ADDRESS: 613 S HANCOCK ST

Proposal: Demolish additions; construct three-story rear addition

Review Requested: Final Approval

OVERVIEW: This application proposes to demolish a highly altered rear ell and construct a rear addition that encloses a portion of the rear of the main block at 613 S. Hancock Street. No work is proposed to the front façade.

2 Roof Plan
A102 1/4" = 1'-0"

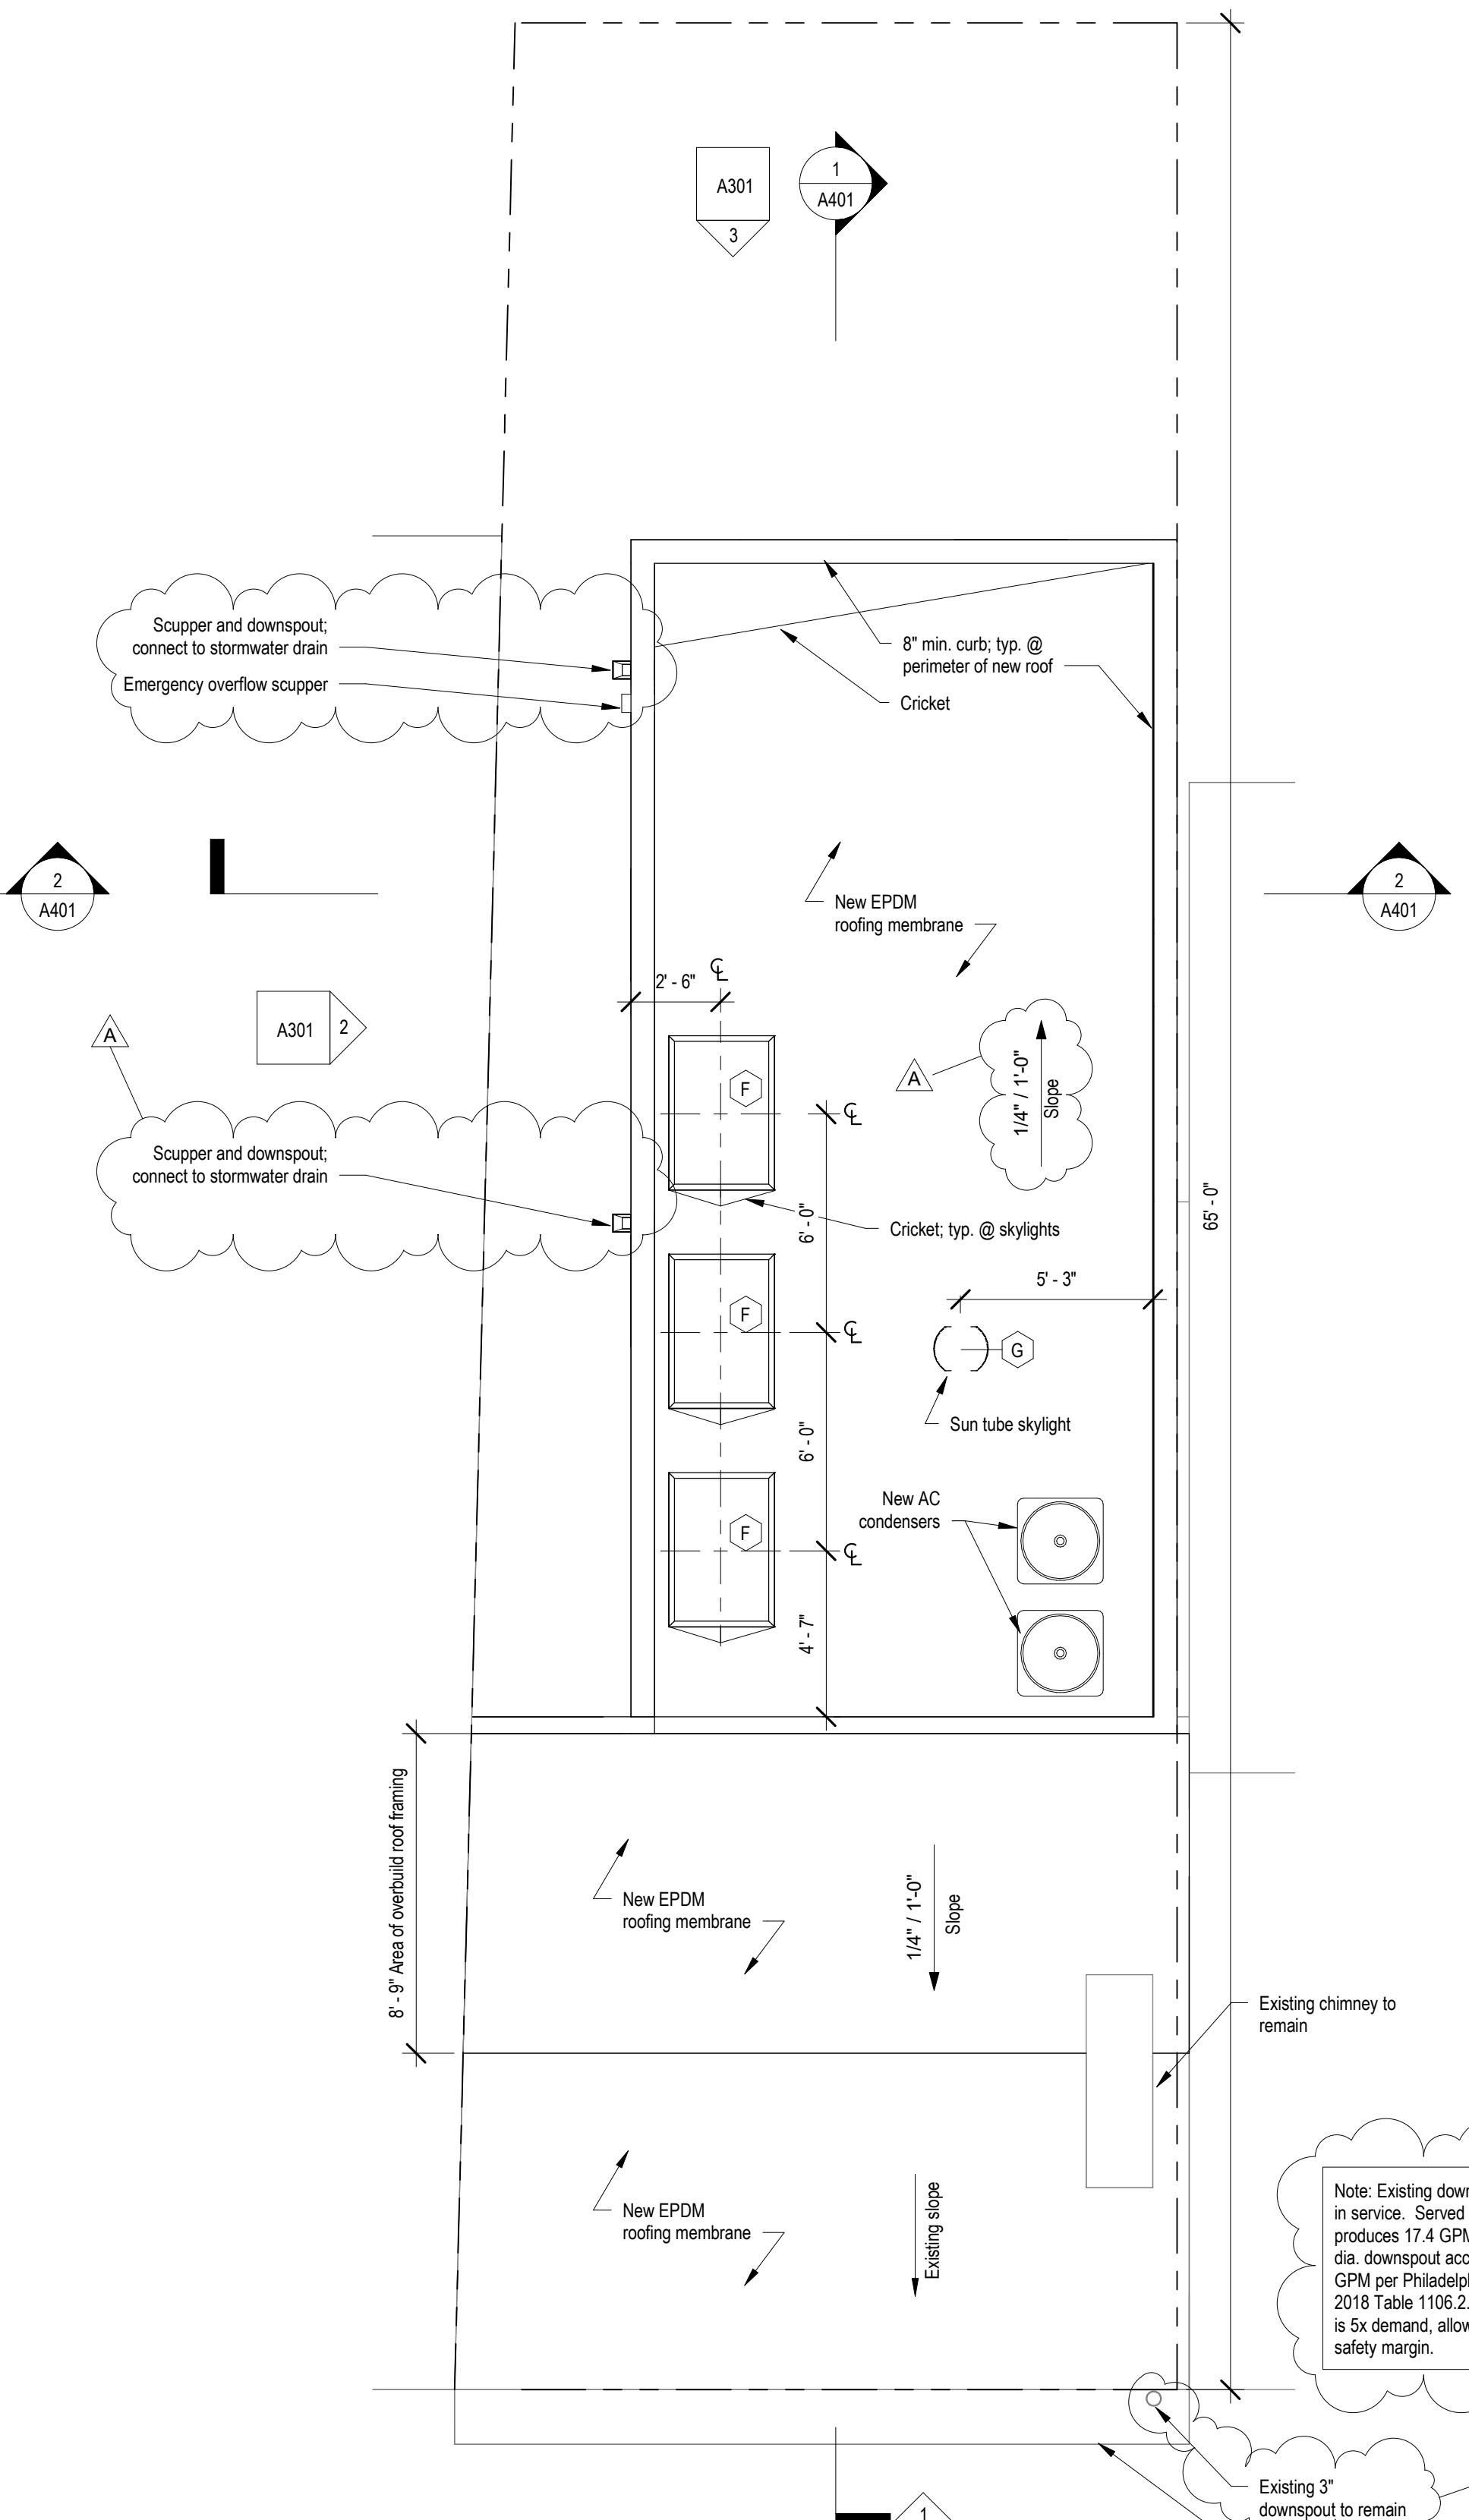
At its December 2024 meeting, the Architectural Committee recommended denial of a revised design that was based upon the Historical Commission's in-concept approval. The Architectural Committee's concerns were that a large amount of water would flow to the downspout of the front façade and that the roof of the addition should be lowered to equal the height of the rear gable. Most of the roof, however, could extend above the height of the back of the rear slope of the historically designated house. The applicant withdrew from consideration at the January 2025 meeting of the Historical Commission.

The applicant has submitted a revised application for the Architectural Committee's consideration. The new proposal includes correspondence from a mechanical engineer stating that the current 3" diameter downspout is sufficient to manage anticipated water flows, the addition's rear slope has been steepened and the downspout on the addition has been moved further from historic building to the middle of the south façade of the addition.

- Mr. Detwiler questioned if a shed roof would simplify the management of water runoff. He stated that rear ell roofs typically slope to one side, and the proposal would cause significant water runoff to the gutter of the historic building.

- Mr. Cluver suggested that a five-inch downspout is incompatible in scale with the historic building.
 - Mr. Katovitch responded that the proposal calls for a four-inch downspout. He continued that he will consult with an MEP engineer regarding the building's water management.

- Interior-only renovation of existing front portion of building to remain.
- Existing front roof shall be built over to adjust pitch, to allow all stormwater from the remaining existing roof to slope to the existing front downspout. Downspout sizing has been verified by an MEP engineer to be acceptable to remain.

371 sf of roof area results in 17.4 gpm of stormwater.

Based on PPC 2018 Table 1106.2, the 3" downspout can handle 87 gpm of stormwater, so it should be able to remain in service.

- Mr. Katovitch responded that the proposed shed roof slopes to the alley and is curved at the edge to contain and shed runoff. He stated that the downspout would be able to handle the water runoff.

1 Longitudinal Section
A401
1/4" = 1'-0"

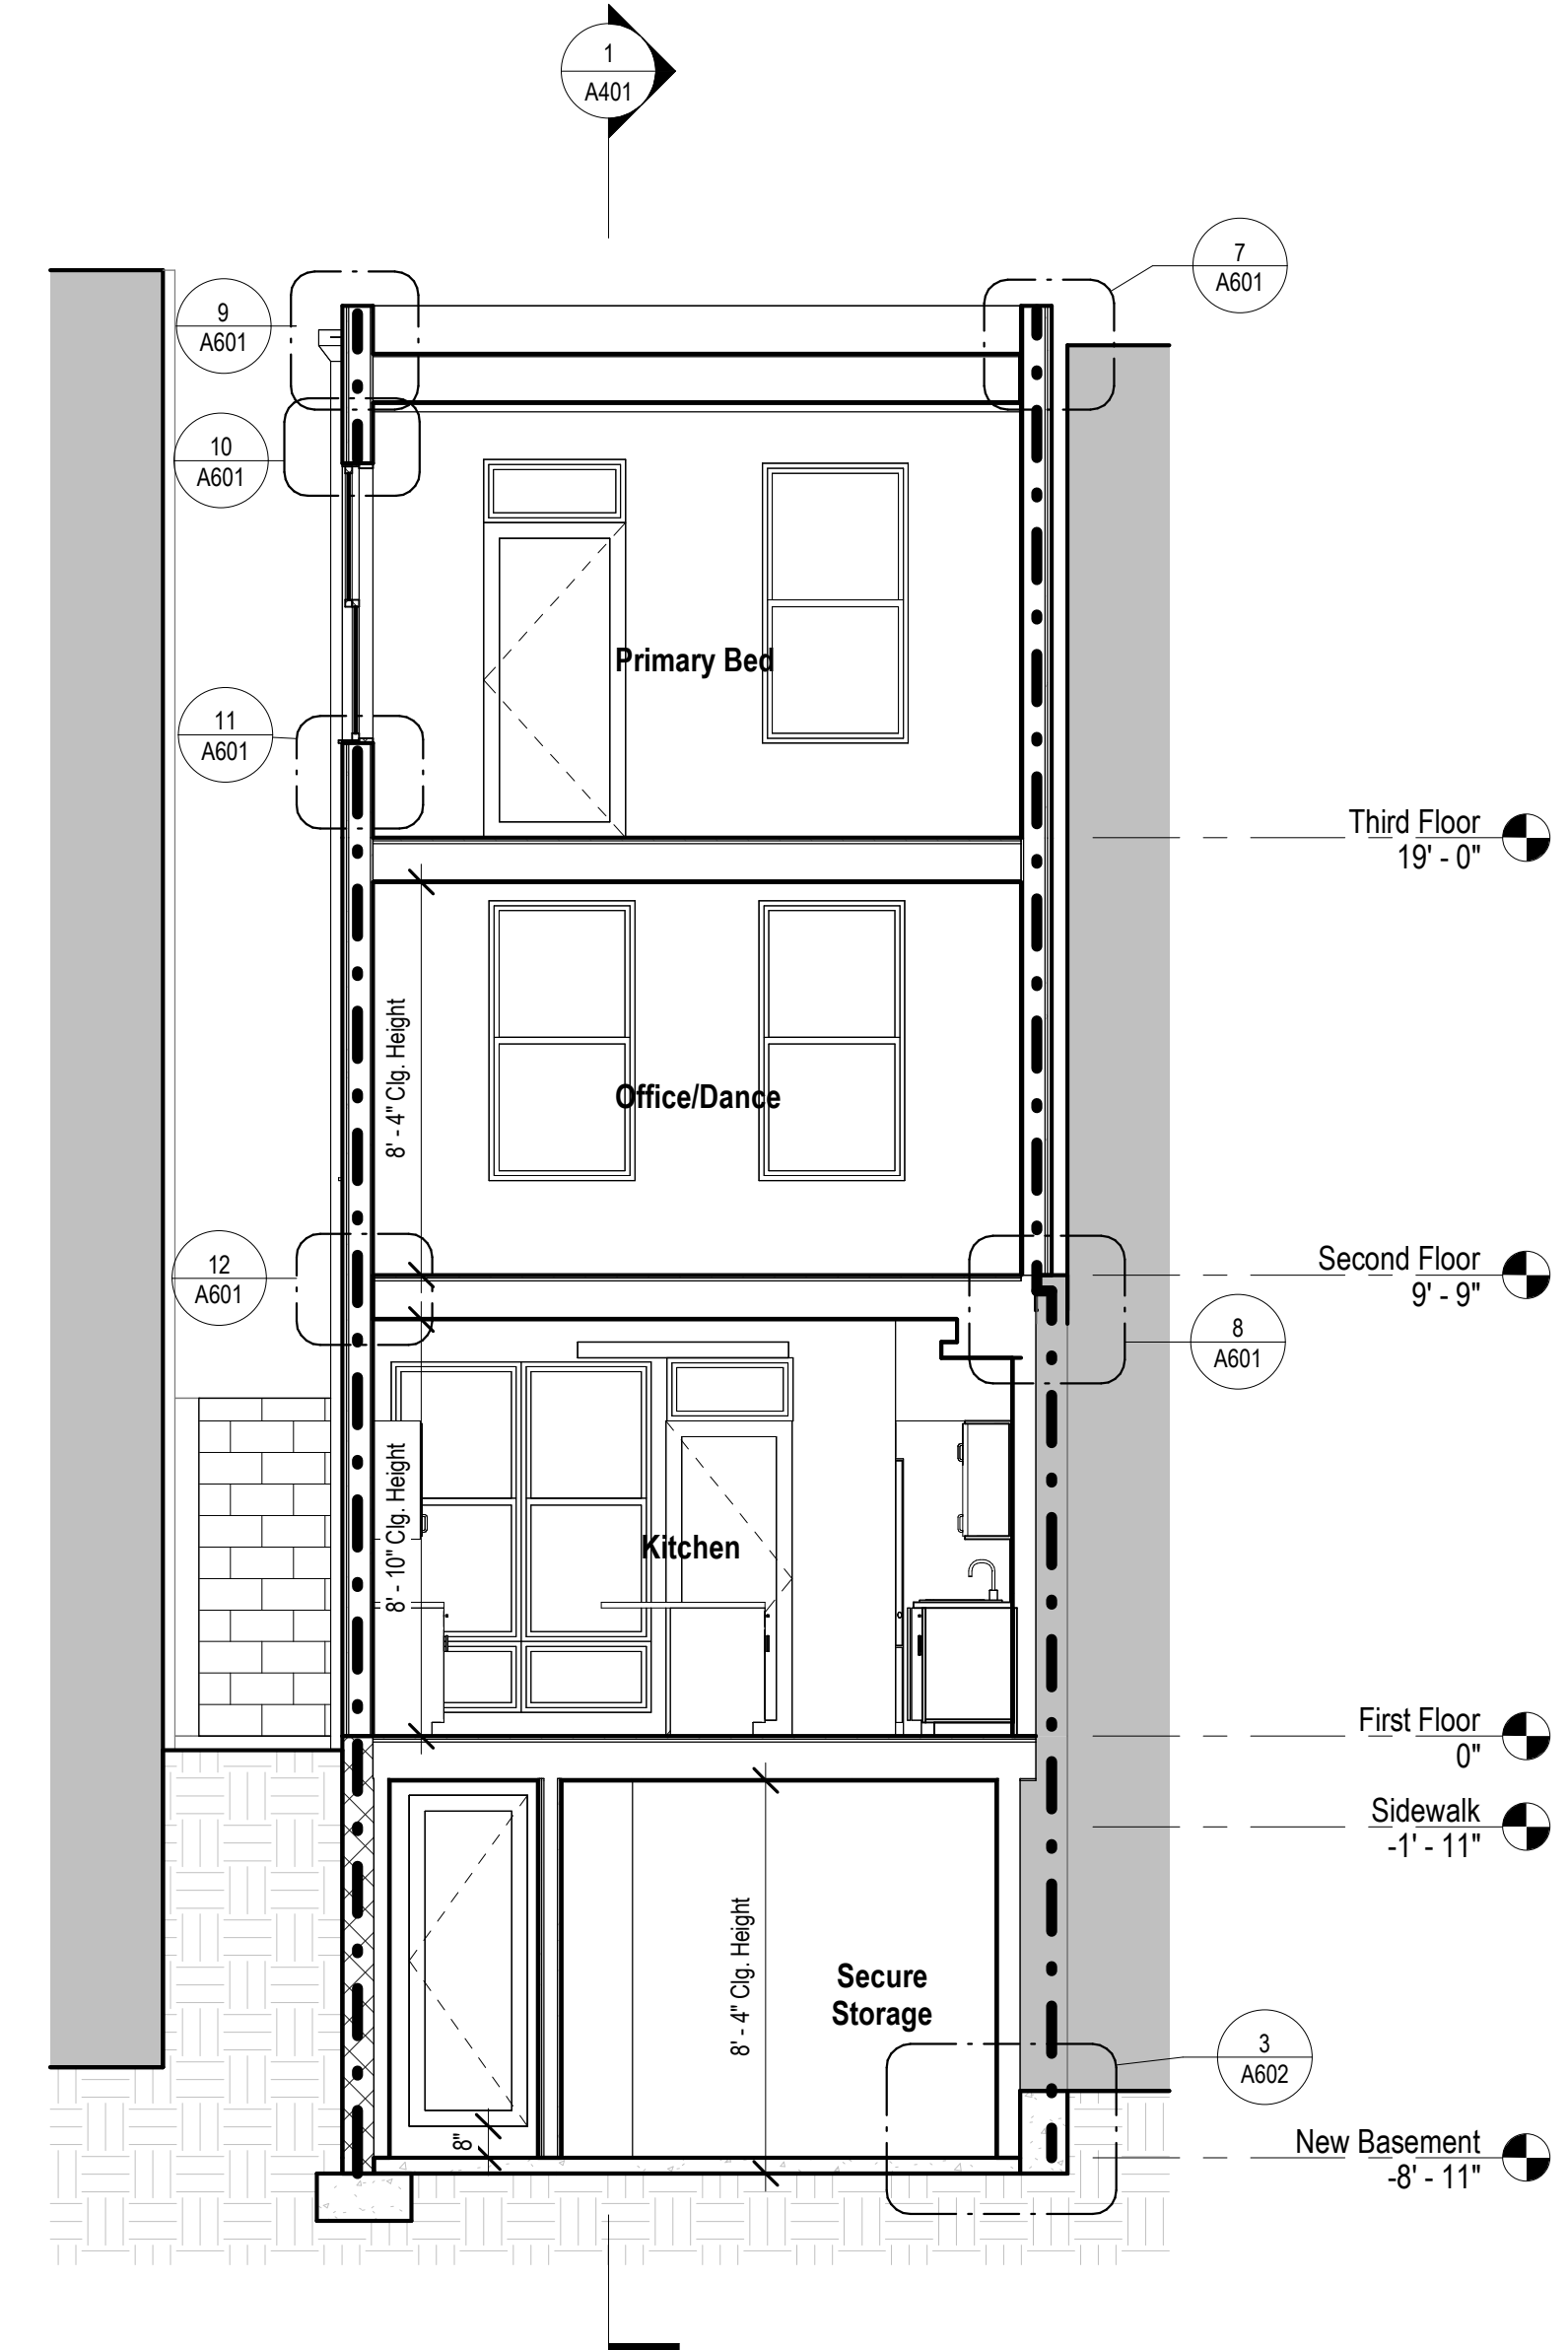
- Mr. McCoubrey recommended that a notch be taken out of the height of the addition's roof where it abuts the historic house. He stated that nearly all of the addition's ceiling heights could remain as proposed.

- Mr. Katovitch expressed concern with building code compliance if the notch was taken out.
- Mr. Detwiler asked about the ceiling heights in the addition.

- Ms. Stein stated that the Architectural Committee has never received a proposal where the height of the addition necessitates that all water runoff at an historic house is directed to the front gutter. She questioned if a gutter path could be created at the five-foot wide gap between the addition and the house to the north.

- Mr. Detwiler suggested that the project design has a commercial feel. He stated that a cricket and a reduced roof height where the addition meets the historic house is preferred.

- Mr. Cluver observed, based upon the section drawing, that the height of the addition could not be reduced to below the rear eave of the original house. However, the addition could be at the same height as the eave.

- The rear ell of the building at 613 S. Hancock Street faces S. Howard Street, a short, dead-end alley used primarily for parking.
- The Historical Commission reviewed and approved a revised in-concept application in June 2024.
- As designed, all water runoff from the roof of the historic house is directed to the front gutter.
- The roof of the addition sits higher than the rear slope of the historic house's roof.

- Owing to the addition's height where it abuts the historic house and the transfer of all water to the front gutter of the historic house, the application fails to satisfy Standards 2 and 9.
- The roof of the addition should be lowered so that it meets the back slope of the existing roof at the eave in order to satisfy the Standards.

- Mr. Katovitch responded that the proposed third-floor ceiling height is 9 feet 4 inches.

- Mr. Katovitch replied that the client was not happy with the solution suggested by Mr. Cluver. He expressed concern that incorporating these suggestions would require additional time for reconsideration by the Architectural Committee and the Historical Commission.

- Mr. McCoubrey stated that the suggested changes could be executed for consideration by the Historical Commission at its next meeting, and the project would not have to return to the Architectural Committee.
